Redcar & Cleveland Borough Council
Adults and Communities

Memo

| Proposal: | PARTIAL DISCHARGE OF CONDITION 28 (CONSTRUCTION TRAFFIC ASSESSMENT) OF OUTLINE PLANNING PERMISSION R/2020/0357/OOM FOR DEMOLITION OF EXISTING STRUCTURES ON SITE AND THE DEVELOPMENT OF UP TO 418,000 SQM (GROSS) OF GENERAL INDUSTRY (USE CLASS B2) AND STORAGE OR DISTRIBUTION FACILITIES (USE CLASS B8) WITH OFFICE ACCOMMODATION (USE CLASS B1), HGV AND CAR PARKING AND ASSOCIATED INFRASTRUCTURE WORKS ALL MATTERS RESERVED OTHER THAN ACCESS |
| Premises: | South Tees Development Corporation, Trunk Road, Redcar, TS10 5QW |

Figure 2

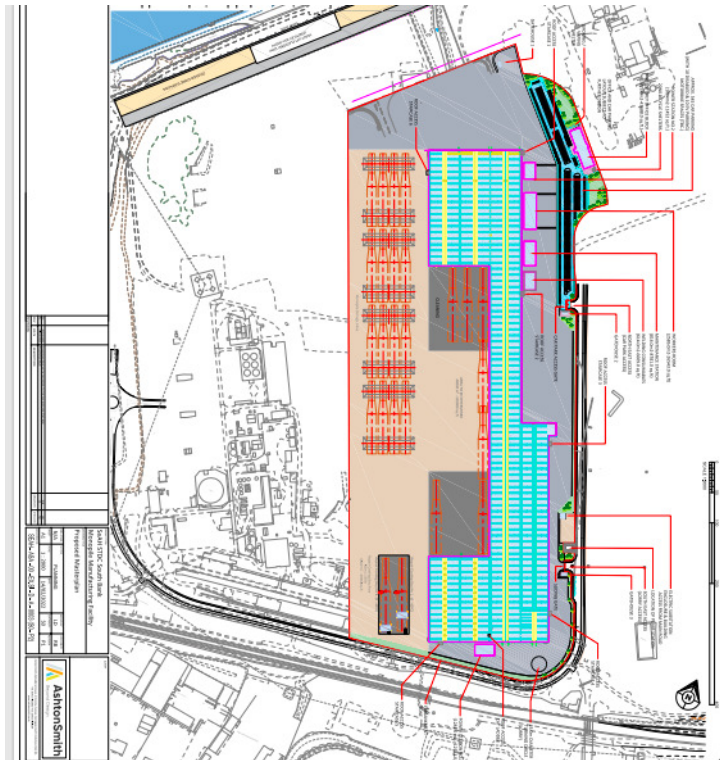
However, the Air Quality Assessment for the SEAH site includes the coke ovens shown the proposed masterplan in Figure 2

Figure 3 shows the area in relation to the area covered by the outline permission (R/2020/0357/OOM) (black line boundary) and it is only this area that can be discharged at this time.

The Air Quality Assessment is acceptable to partially discharge condition 28 however, this is only currently applicable to the area enclosed by the black boundary line as denoted in Figure 3.
